Chilled Water System Communication and Controls Replacement

Solicitation Number: CO-00090

ADDENDUM 1

09/15/2016

Attachment #1

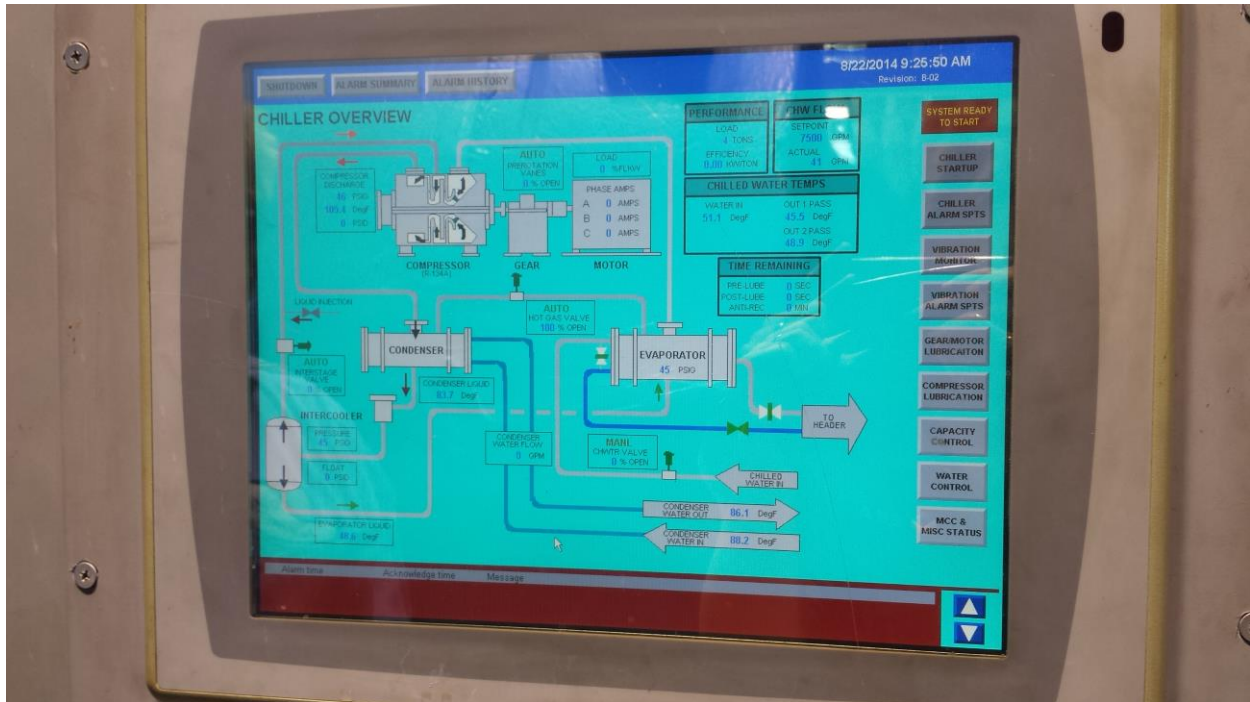
37. **Q: Please provide bit maps of the existing Johnson Controls graphics for the Commerce Chilled Water Plant. We need this information to determine the number of screens required for the control system.**

R: There are an approximate 20 screens required per PLC. See Attachment #1 for picture of a typical chiller PLCs located at the Commerce St. Plant.

This picture shows a typical PLC screen for PLCs #1-5. PLC #6 will have a different screen layout but is expected to have a similar number of screens.

CHILLED WATER FLOW METERS
UPGRADE PROJECT
COMMERCE STREET
CHILLED WATER PLANT (EAST)
DETAILS

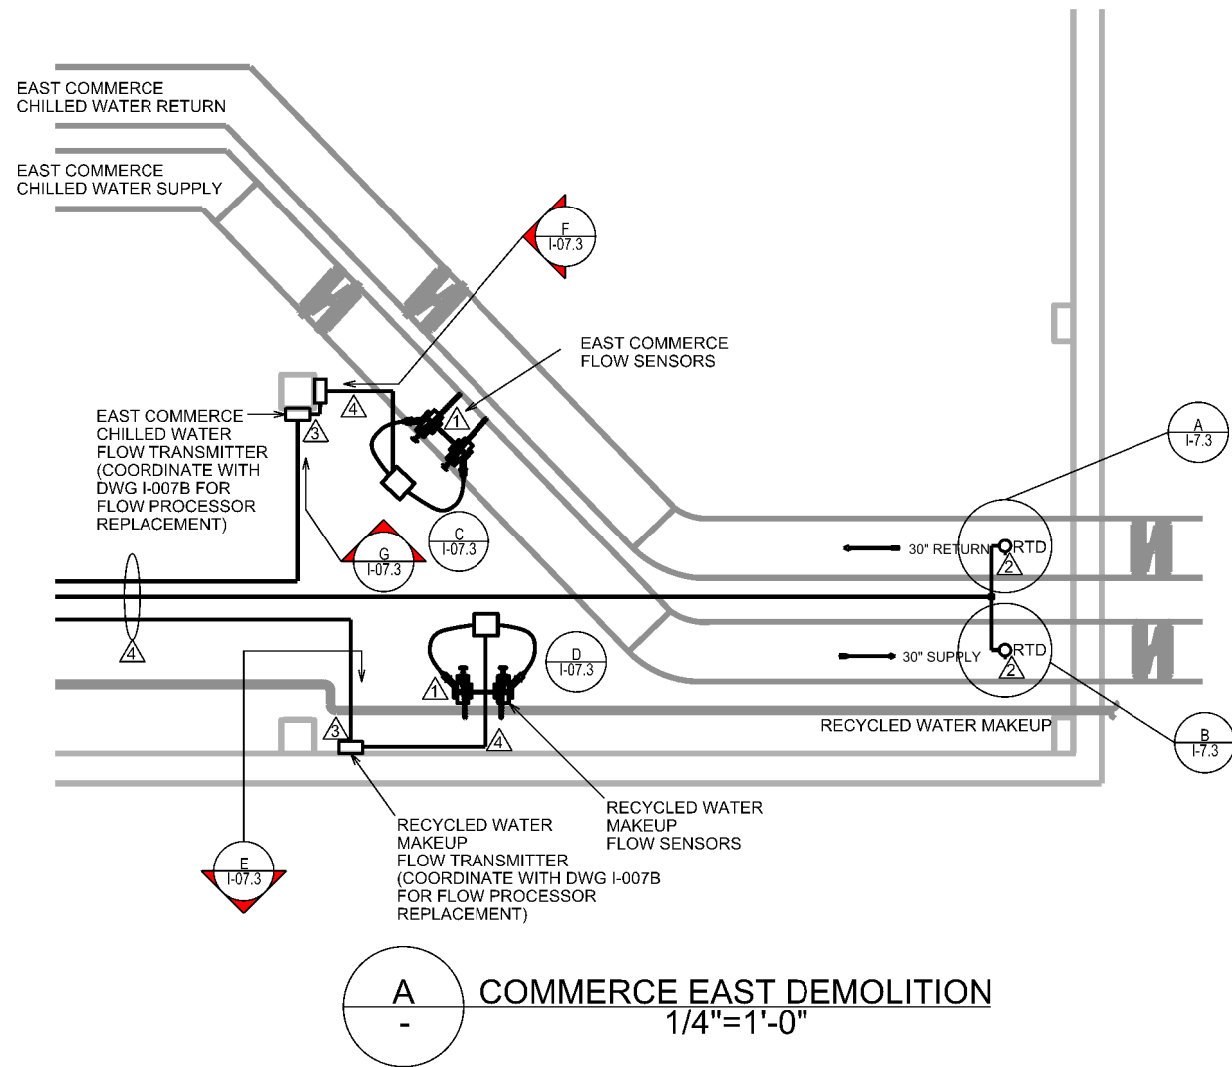
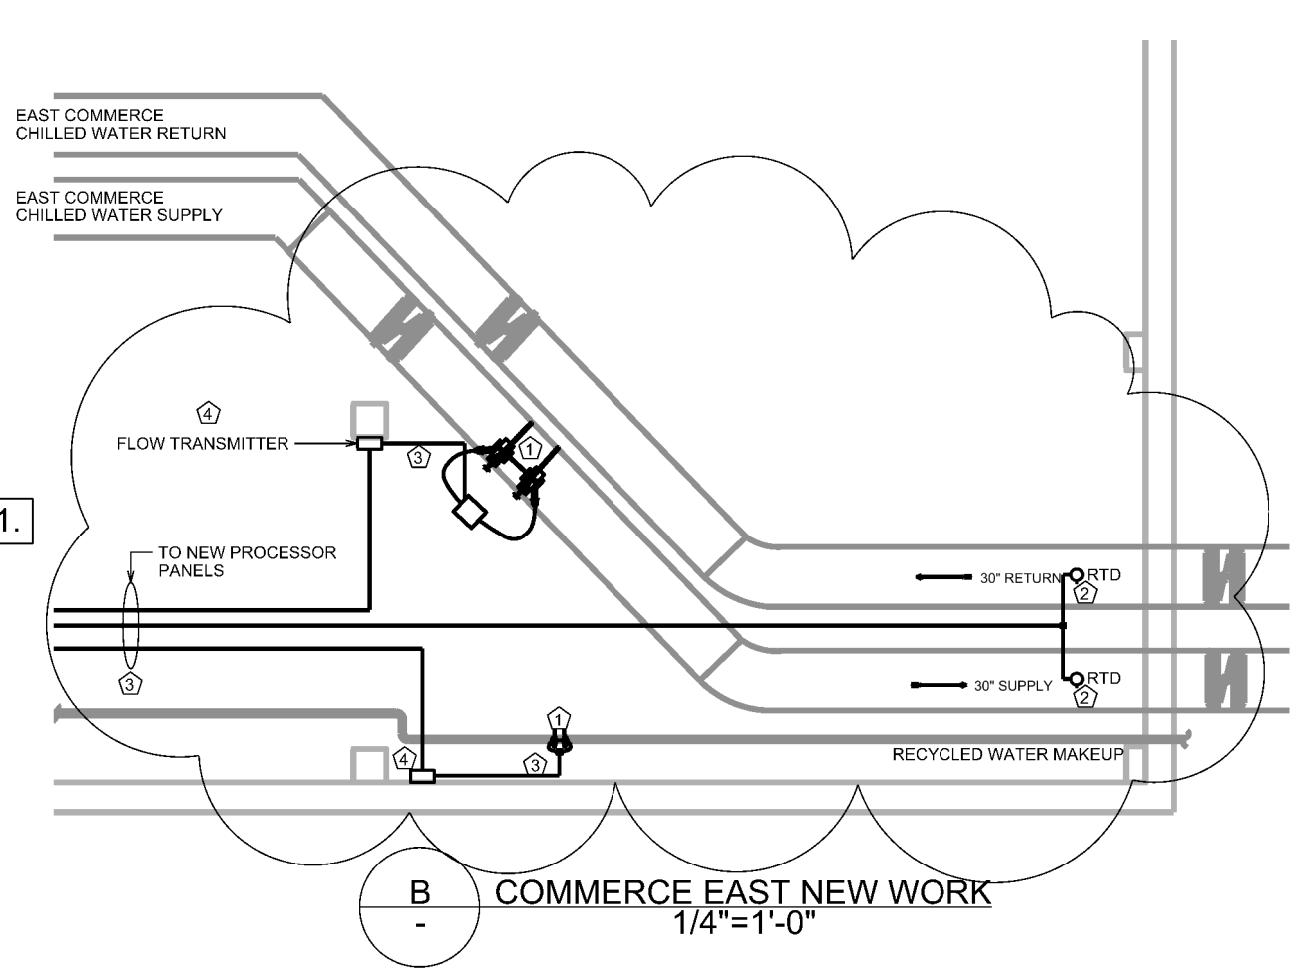
- R: No, SAWS does not currently have a standard Communications Module.
33. **Q: I-07.4—New Work Key Notes 4 and 5 are missing.**
- R: Please reference item #3 of Changes to the Plans of this Addendum.

3. SHEET I-07.4:

REMOVE and REPLACE sheet I-07.4 with the attached sheet.

Δ	NEW WORK KEY NOTES:
1	INSTALL NEW ULTRASONIC FLOW SENSORS IN APPROXIMATE LOCATION SHOWN. COORDINATE WITH MANUFACTURER FOR OPTIMAL LOCATION GIVEN EXISTING CONSTRAINTS. REPLACE INSULATION AND COVER ENTIRE PIPE WHERE SENSORS ARE TO BE INSTALLED. APPLY INSULATION AND INHERENT VAPOR RETARDANT MATERIAL TO PIPE. THICKNESS OF INSULATION TO MATCH EXISTING. INSTALL NEW CONDUIT AND NEW RACEWAY FOR ENTIRE CABLE RUN. REFER TO SCHEMATICS FOR SIZES.
2	INSTALL NEW RTD IN EXISTING THERMO-WELL ADJUST LENGTH OF RTD PROBE TO FIT EXISTING WELL. REPLACE INSULATION AROUND ENTIRE PIPE FOR A MINIMUM OF 6" ON EITHER SIDE OF PROBE. INSTALL NEW CABLE AND CONDUIT FOR ENTIRE CABLE RUN. REFER TO SCHEMATICS FOR SIZES.
3	INSTALL RIGID CONDUIT FOR ENTIRE RUN. FLEXIBLE CONDUIT ALLOWED ONLY AT TERMINATION ENDS. REFER TO SCHEMATICS FOR SIZES.
4	INSTALL ULTRASONIC FLOW TRANSMITTER IN NEW PANEL. COORDINATE WITH EEA'S DRAWINGS FOR ADDITIONAL REQUIREMENTS. REFER TO DWG. I-07.4 FOR LOCATION OF PROCESSOR.

CHILLED WATER FLOW METERS
UPGRADE PROJECT
COMMERCE STREET
CHILLED WATER PLANT (WEST)
EXHIBITS

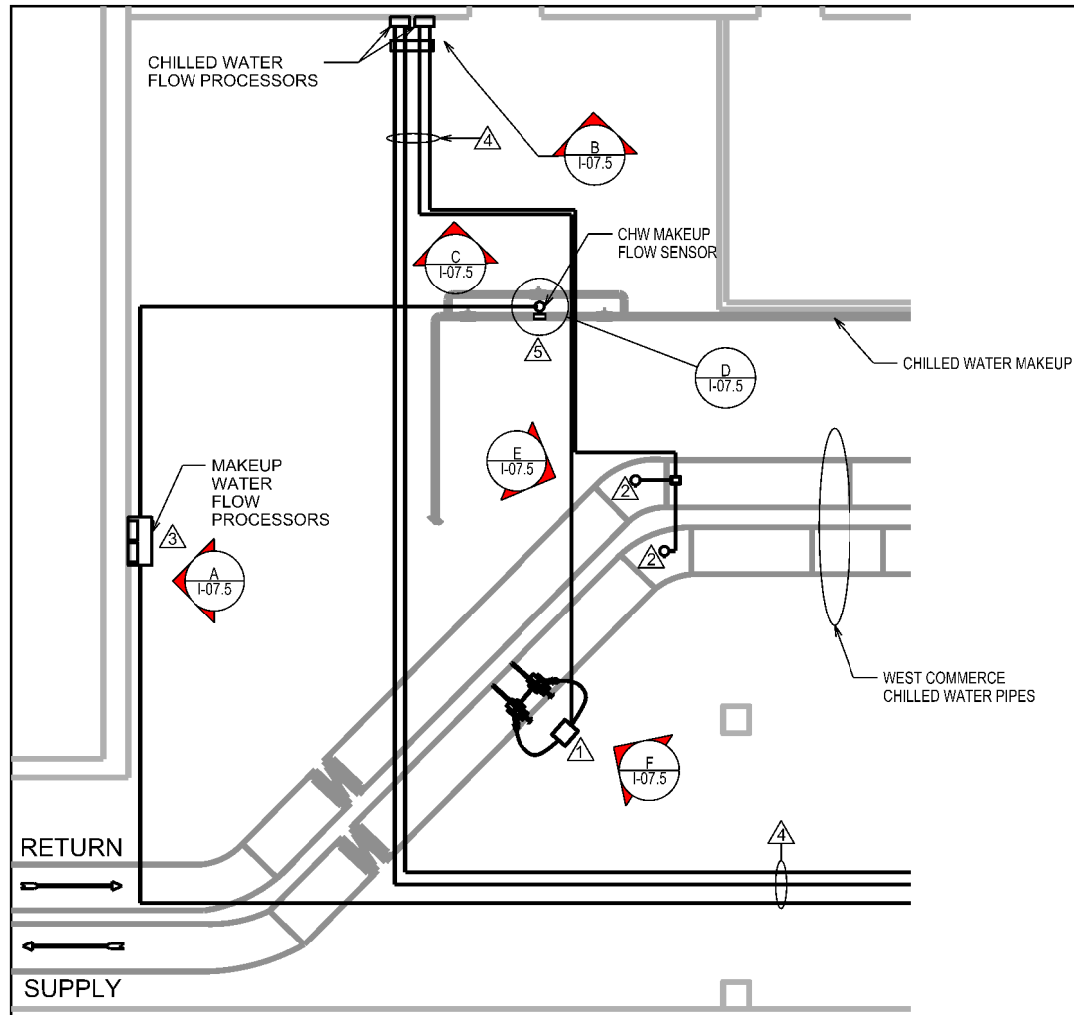
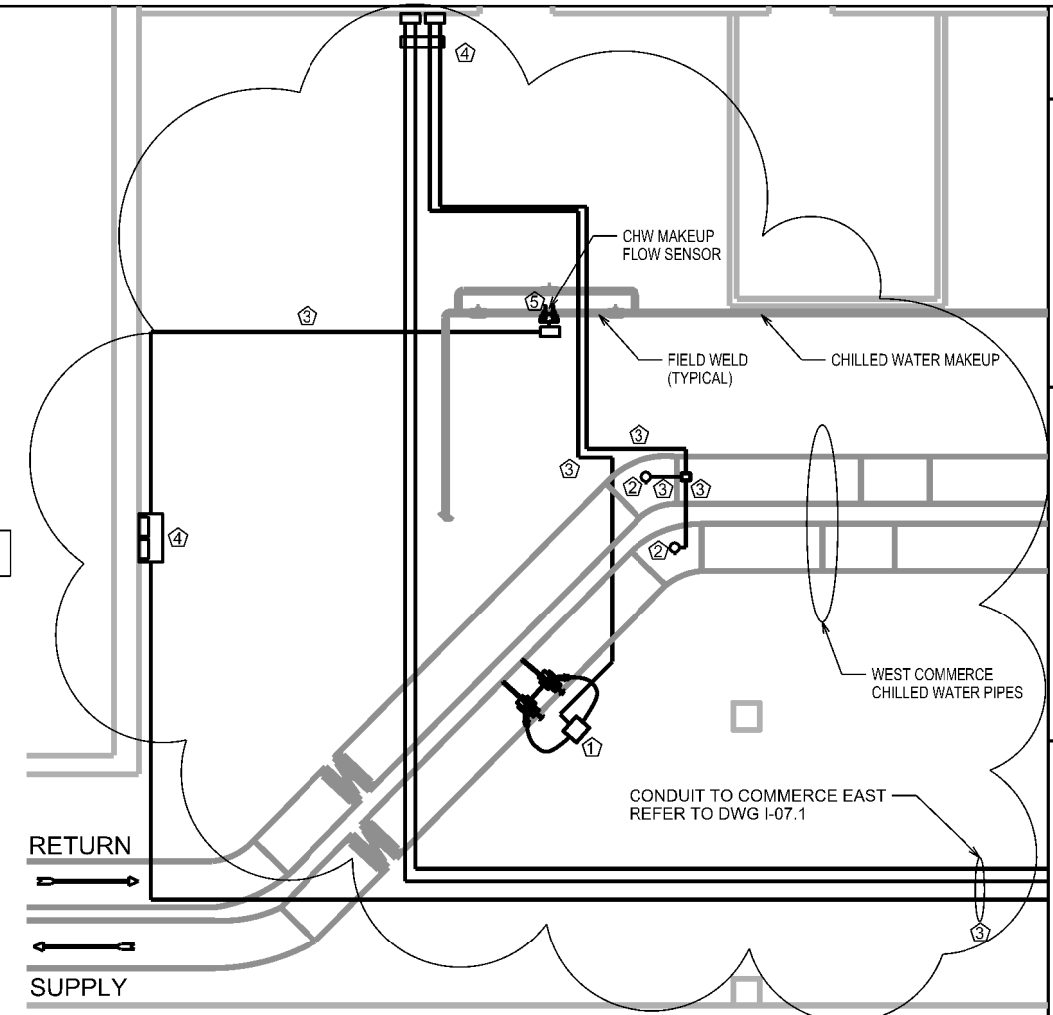
4. SHEET I-07.5:

REMOVE and REPLACE sheet I-07.4 with the attached sheet.

⌘	NEW WORK KEY NOTES:
1	INSTALL NEW ULTRASONIC FLOW SENSORS IN APPROXIMATE LOCATION SHOWN. COORDINATE WITH MANUFACTURER FOR OPTIMAL LOCATION GIVEN EXISTING CONSTRAINTS. REPLACE INSULATION AND COVER ENTIRE PIPE WHERE SENSORS ARE TO BE INSTALLED. APPLY INSULATION AND INHERENT VAPOR RETARDANT MATERIAL TO PIPE. THICKNESS OF INSULATION TO MATCH EXISTING. INSTALL NEW CONDUIT AND NEW RACEWAY FOR ENTIRE CABLE RUN. REFER TO SCHEMATICS FOR SIZES.
2	INSTALL NEW RTD IN EXISTING THERMO-WELL ADJUST LENGTH OF RTD PROBE TO FIT EXISTING WELL. REPLACE INSULATION AROUND ENTIRE PIPE FOR A MINIMUM OF 6" ON EITHER SIDE OF PROBE. INSTALL NEW CABLE AND CONDUIT FOR ENTIRE CABLE RUN. REFER TO SCHEMATICS FOR SIZES.
3	INSTALL RIGID CONDUIT FOR ENTIRE RUN. FLEXIBLE CONDUIT ALLOWED ONLY AT TERMINATION ENDS. REFER TO SCHEMATICS FOR SIZES.
4	INSTALL ULTRASONIC FLOW TRANSMITTER AND FLOW PROCESSOR IN NEW PANEL. COORDINATE WITH EEA'S DRAWINGS FOR ADDITIONAL REQUIREMENTS.

5	REPLACE PIPE AS NEEDED AND INSTALL ULTRASONIC FLOW SENSORS IN APPROXIMATE LOCATION SHOWN. COORDINATE WITH MANUFACTURER FOR OPTIMAL LOCATION OF SENSORS TO MAXIMIZE ACCURACY GIVEN EXISTING CONSTRAINTS. INSTALL NEW RACEWAY FOR ENTIRE CABLE RUN. REFER TO SCHEMATICS FOR SIZES.
